Tuesday, August 25, 2020
Medway Planning and Economic Development Board
155 Village Street
Medway, MA 02053

SALMON FIELD CHANGE – VILLAGE STREET:

**Salmon Field Change – Revisions to Exit
at Waterside Run and Village Street**

**Salmon Field Change – Village Street
Crosswalks**

PREPARED FOR:	CONTINUING CARE MANAGEMENT, LLC 1 LYMAN STREET WESTBOROUGH, MASSACHUSETTS 01581	DRAWING:	WATERSIDE RUN ENTRANCE MODIFICATION
PROJECT:	SALMON HEALTH AND RETIREMENT COMMUNITY 259, 261, 261R AND 263 VILLAGE STREET MEDWAY, MASSACHUSETTS 02053	CONSTRUCTION DOCUMENTS	
PLAN SET:

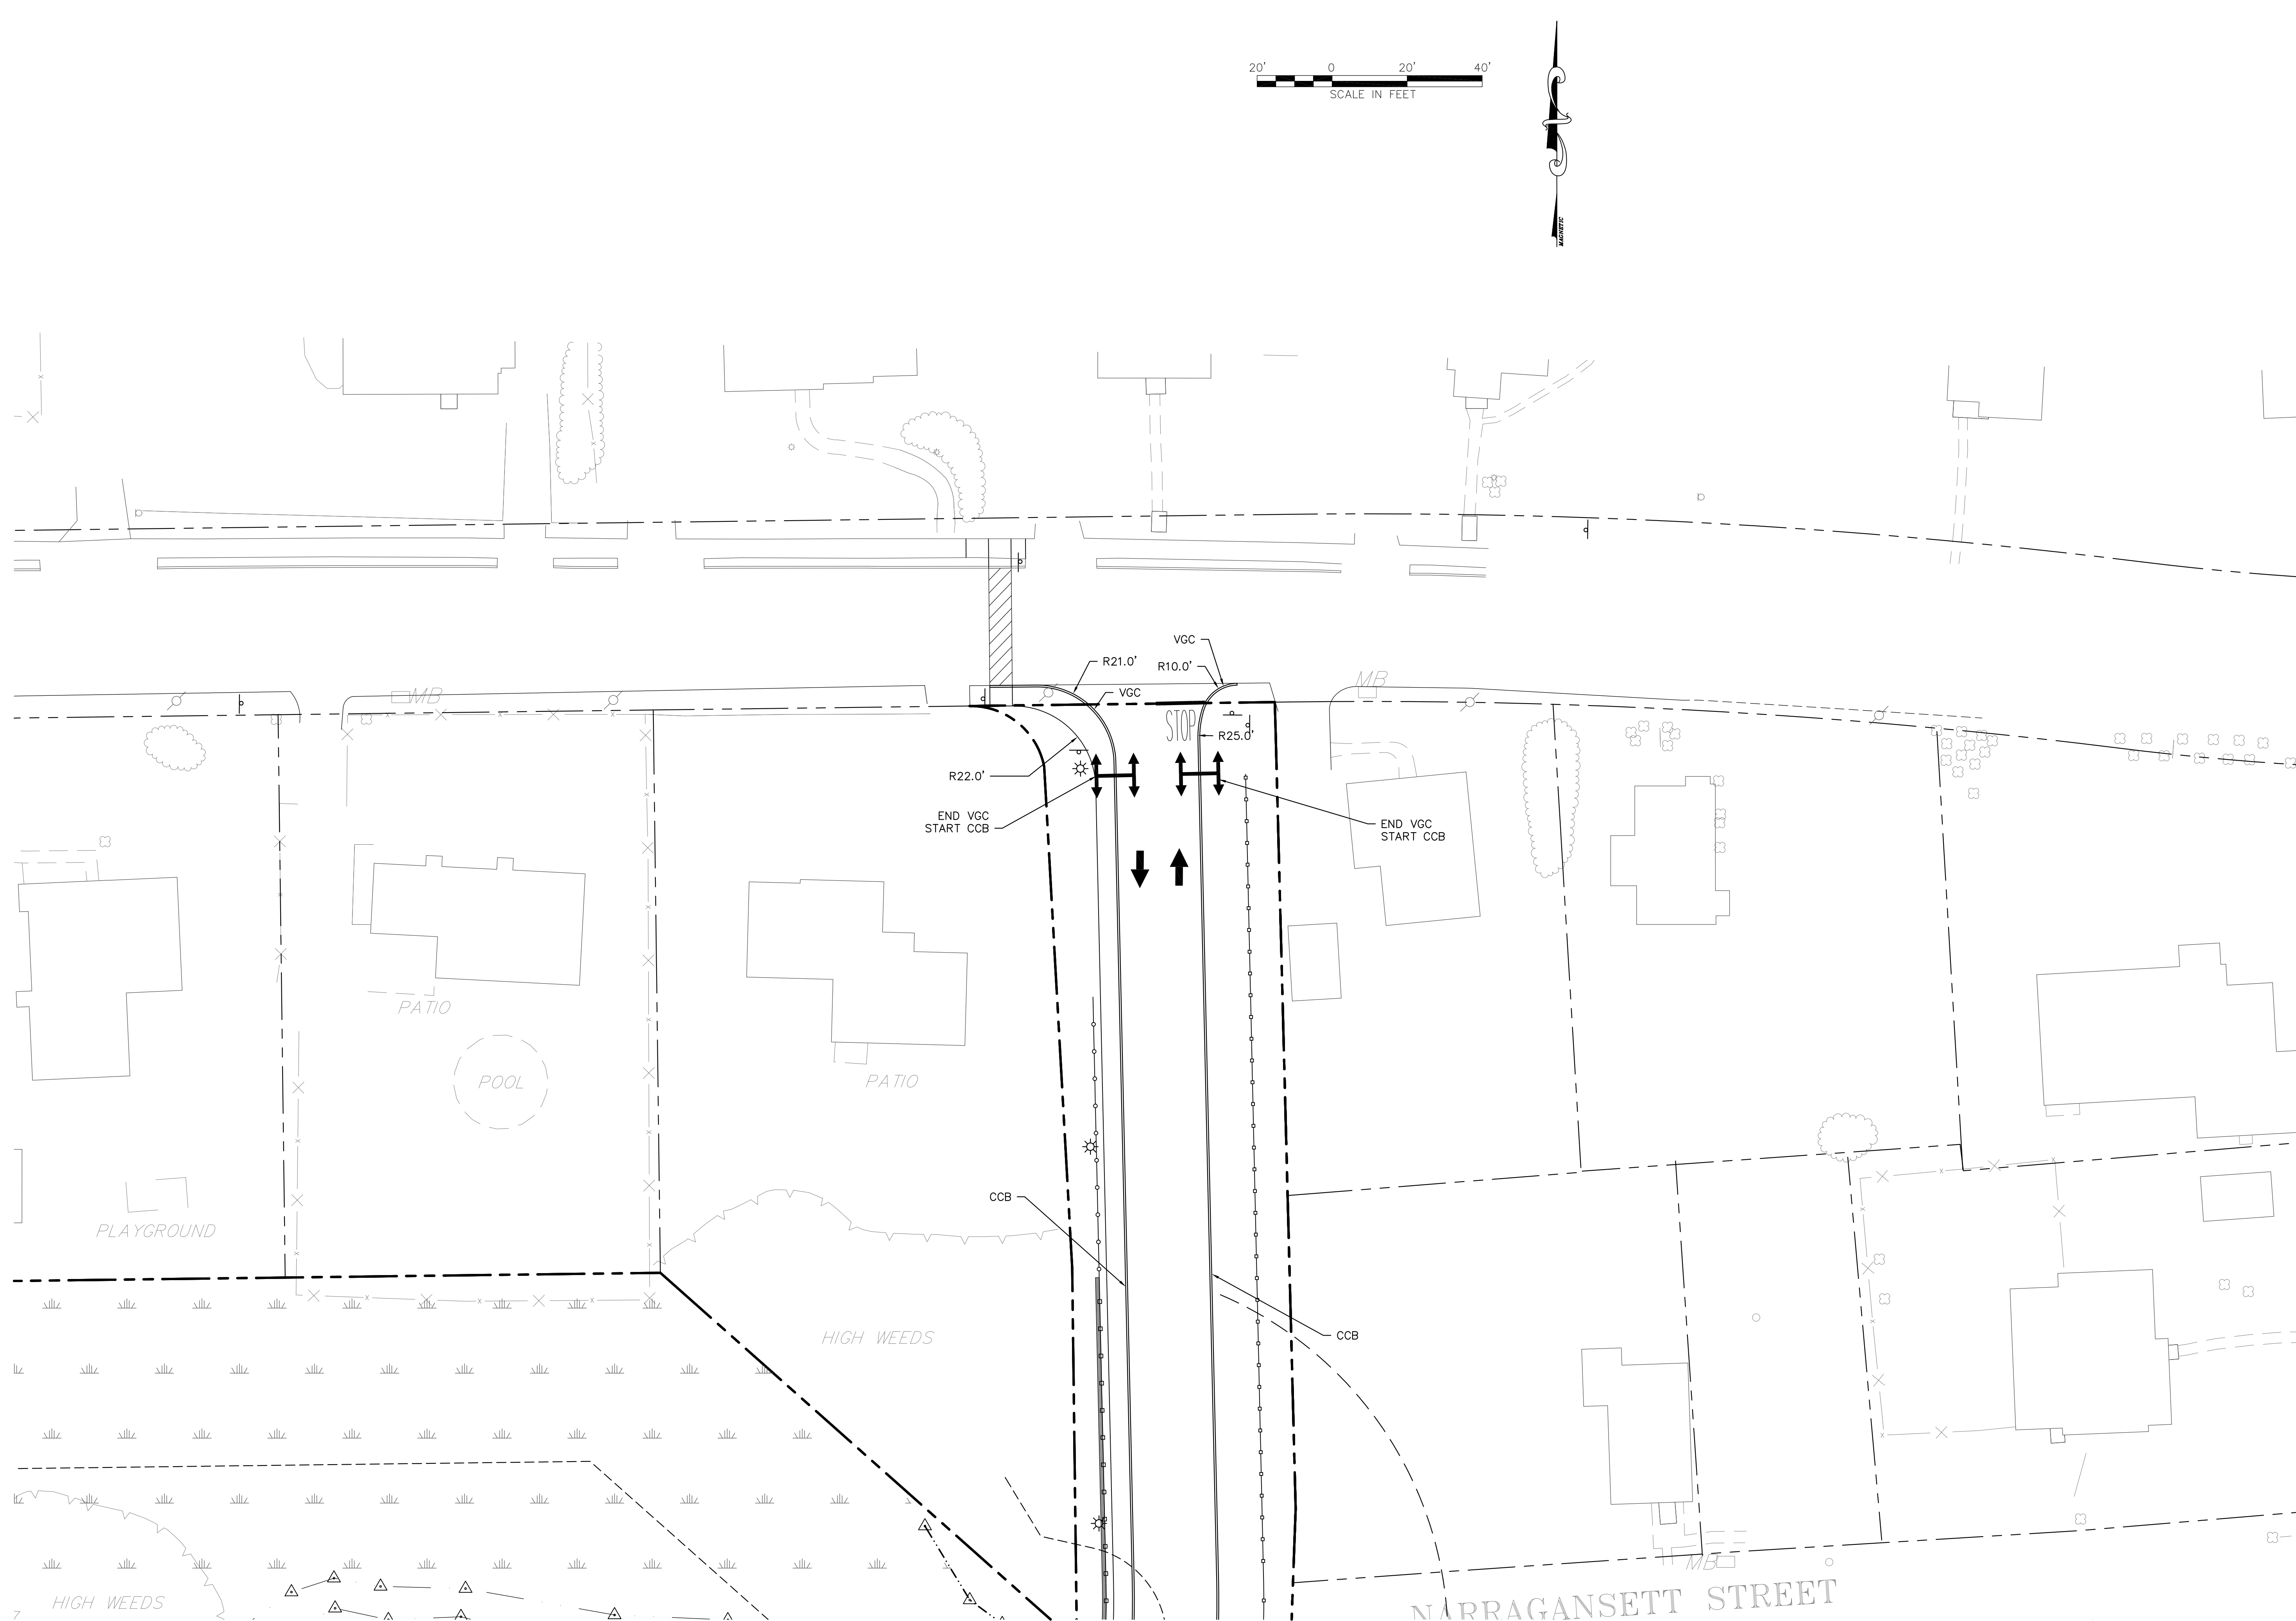
The only comment I have is they should add curb type. Radius should be VGC as provided in the approved Plans.

Attached is the modified curbing for Waterside Run. It maintains the curb setup from the previous plans and just extends it to the property line. Please let me know if you have any questions.

SHEET NO.
C64

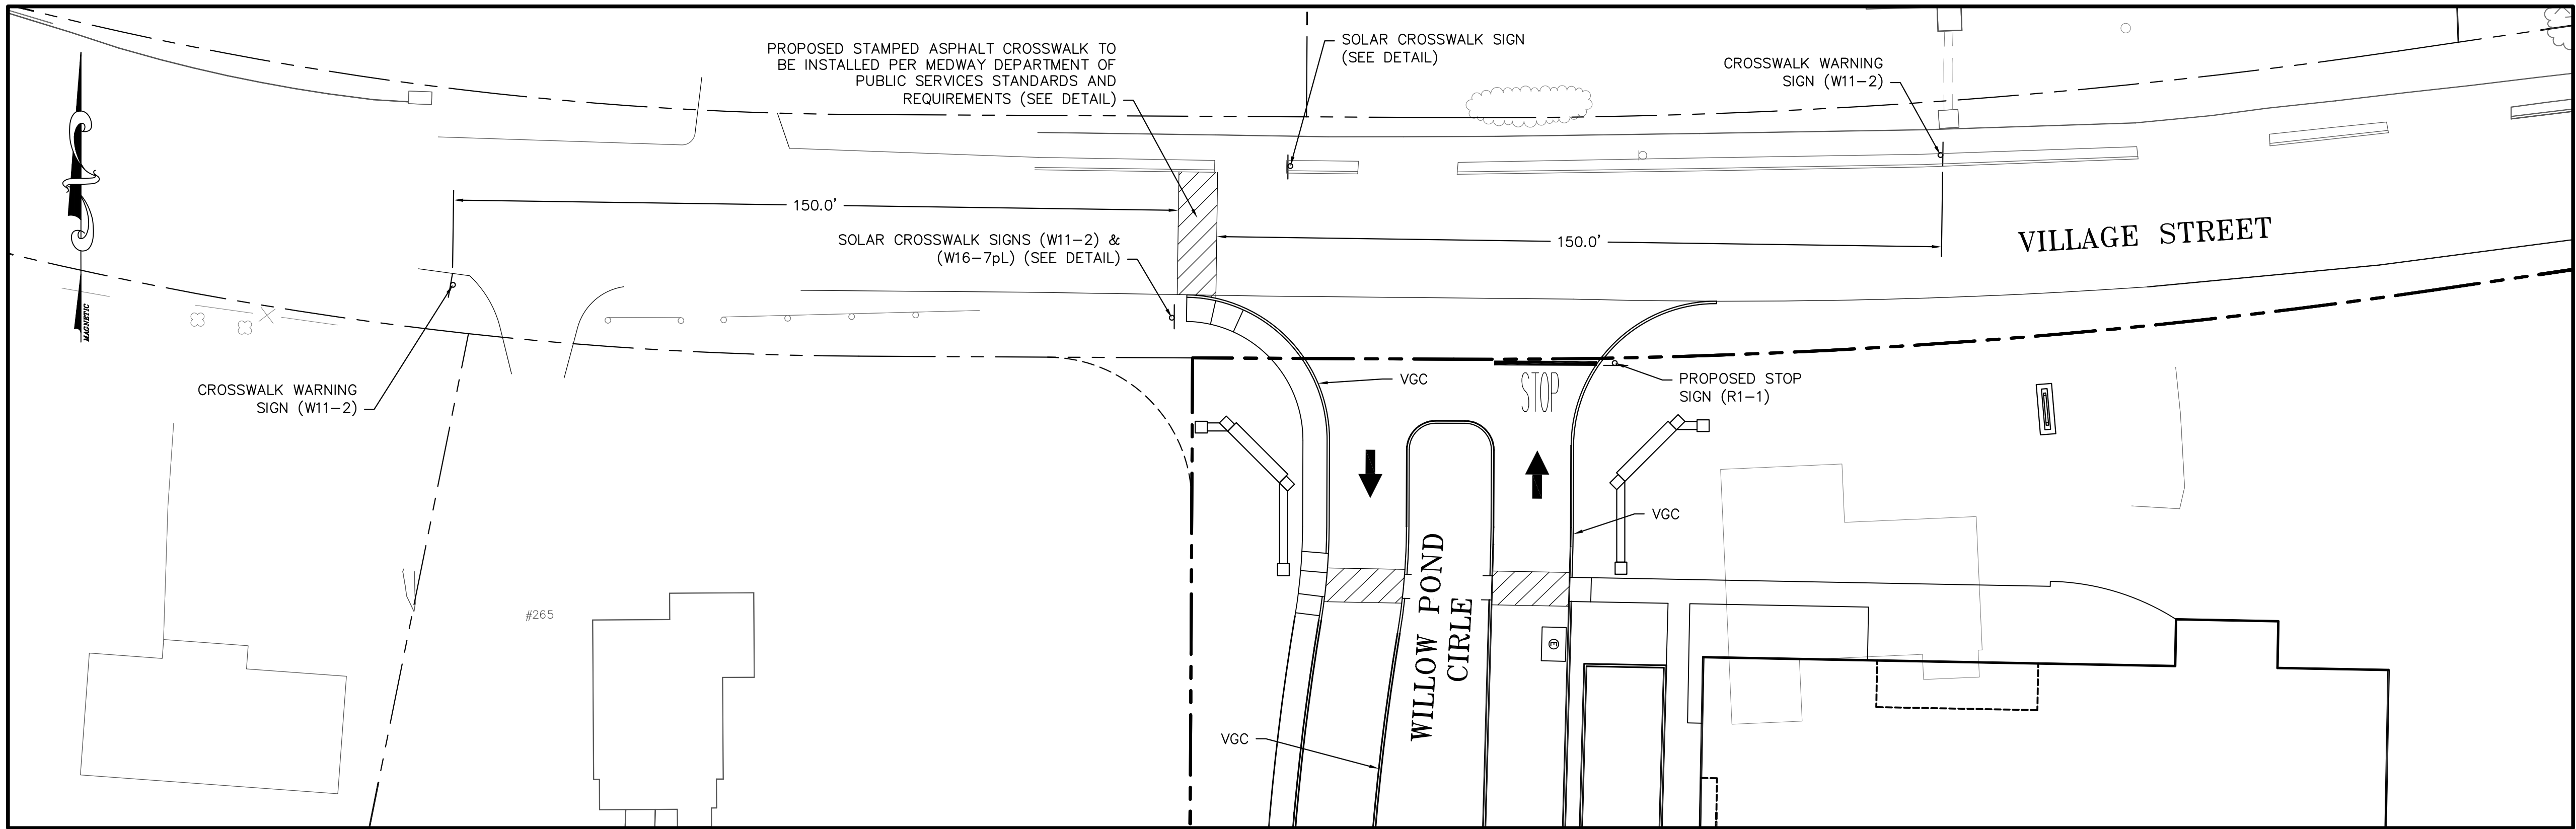
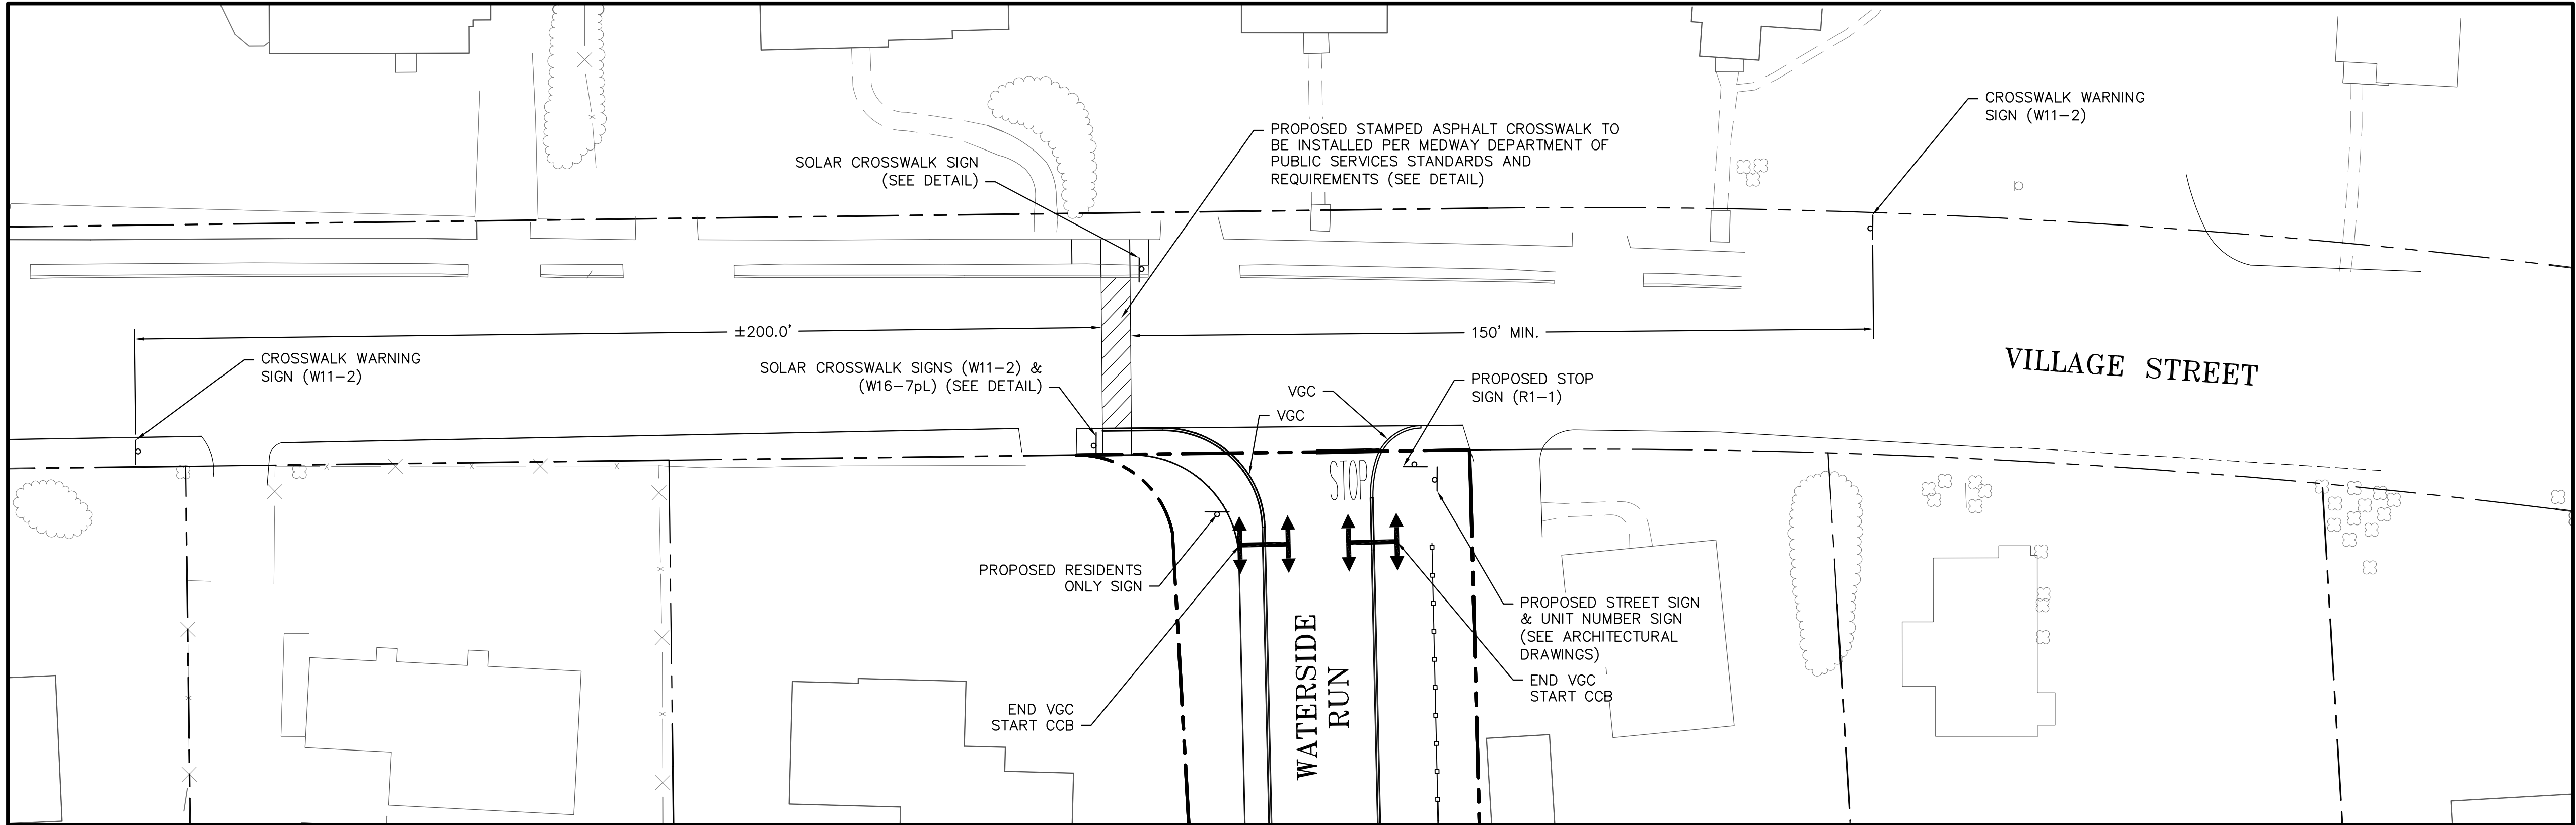
- The landing be on property owned by The Willows or on the Right of Way for Village Street.
- The landing will be a minimum of 5'
- The sidewalk will have a minimum of 4' of clearance near the utility pole in question.
- The sidewalk will be either located on the Willows or on the Right of Way for Village Street.
- None of the proposed modifications will be located on abutting properties.

I took a look at the area for the proposed crosswalk. I thought you would have some property line stakes down to get a better idea of where the sidewalk on Village would fall. It looks like you are proposing a curb at edge of pavement. That leaves a tight squeeze at the telephone pole. It should be more than 36" from what I could tell, but you need to verify that.
